An inspection of the buildings in Church Street, Tulbagh, was done on behalf of the N.M.C. by Kirstin Van Tonder and Gwen Fagan on the 12th and 13th November, 1997. The following report summarises the legal and illegal changes which were found and provisional recommendations on how these might be addressed and the general image of the street be enhanced.

GENERAL ISSUES:

THE CHURCH MUSEUM

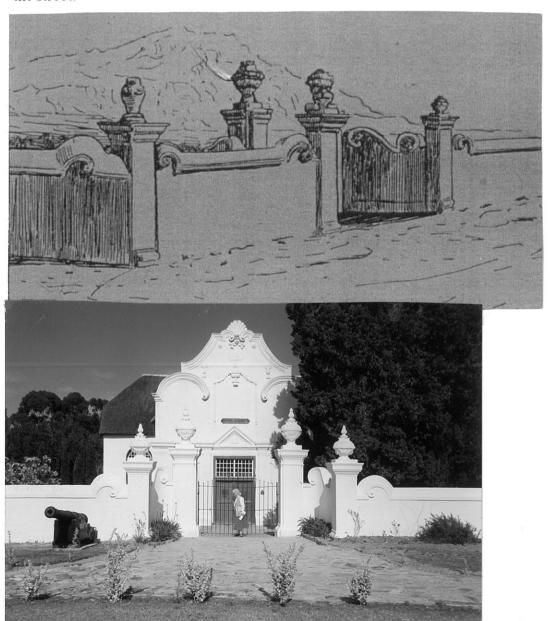
The church is in a good state of repair.

The church would, however appear at its best in a simple landscape of grass spilling up against the white walls with no hard paths, flower beds with stone edging, hedges and spotty planting of various shrubs unrelated to the period when the church was built.

The surrounding landscape should be simplified not only to create a more sympathetic environment to the most beautiful church in the country, but also to provide the lowest possible maintenanc.

Kikuyu which has to be regularly cut and manicured, giving the impression of a suburban lawn, should be killed with a weed-killer.

Planting of an indigenous grass like Kweek or buffalo, both of which need much less watering and are also low maintenance, should be done.

Into the grass should be planted many small spring bulbs like oxalis, chinkerechees, lachenalias, babiana, sparaxis and the other small local bulbs for which Tulbagh is famous. Once these bulbs start growing, the grass is left uncut until the summer, after they have flowered and seeded themselves.

The grass should stretch from the road to up against the walls of the church without a break. Footpaths should be of concrete grass blocks (e.g. Terraforce) planted with the same grass to provide an unbroken grass surface.

All hedges, rose clumps and other shrubs should be removed, perhaps for re-use elsewhere in the street.

Housenumber 10

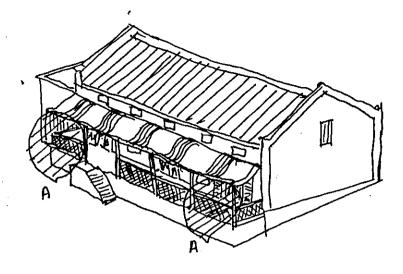
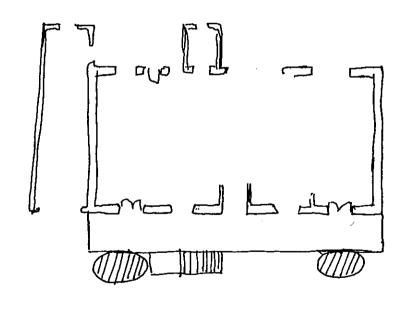
Ē	HOUSE NO 10
	The plan is largely unchanged and the building in a satisfactory condition. However, a veranda has been enclosed with a wall on the east side of the house so that the original kitchen has now been considerably darkened.
	Pillars have been built in the back yard to carry a pergola and the area under this paved with modern tiles. A retaining garden wall has been added.
L	RECOMMENDATIONS:
	A plan of the changes with motivation, should be presented to the N.M.C for consideration. The garden on the street needs to be upgraded.
7

A Klimrose Crepuscule

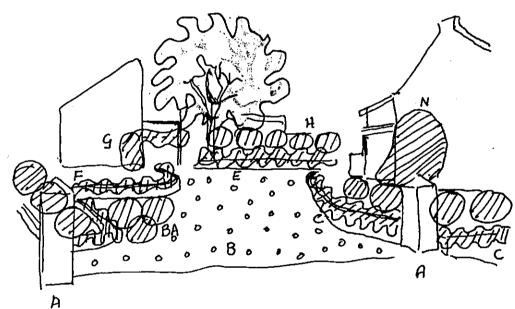
The front garden needs to be upgraded to contribute to the historical atmosphere of the street.

A Pillars to be demolished B Itard stone paving to be softened by inter.

plenting with creeping thyme, digmondia

kweels in patches.

BA Rosa Fortuneana x3 to be planted in holes in paving c Low white wall to be covered with Catmint D Low white wall to be covered with trailing rosemary wall to be covered with Rosa multiflora nava F Low white wall to be covered with trailing g Rosa Bounksia lutea H Row of Parson's Pink China"

I Rosa multiflora nana on either side of the path

I A mixture of red China roses

K Viburnum tinus L Rose La Reine M Roses "Hacartney to form groundcover N Rosa Banksia White)
O Rose "The Bishop"
P Rose "Paul Neyron"

House number 38

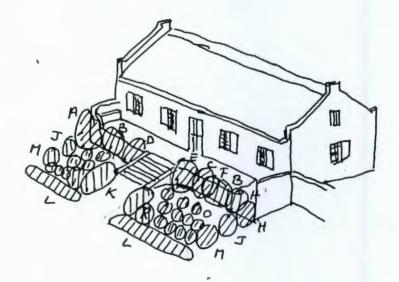
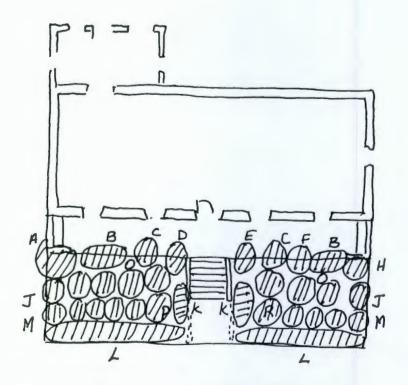
The street garden is planted with conifers which do not enhance the historical atmosphere of the house.

A plan for more suitable planting should be considered.

A Berberis thunbergia atropurpurea
BRose multiflora unknown pink
CRose "Baron Prevost"

DHoneysuckle (Lonicera xamericana) RRose "Homer
ERose "La Reine"
F Golden Privet
HRose "Variegata di Bologna"
JRose "Hugonis"
KLavender hedge "Hidcote blue"
M Selection China roses
L Pink yarrow edging
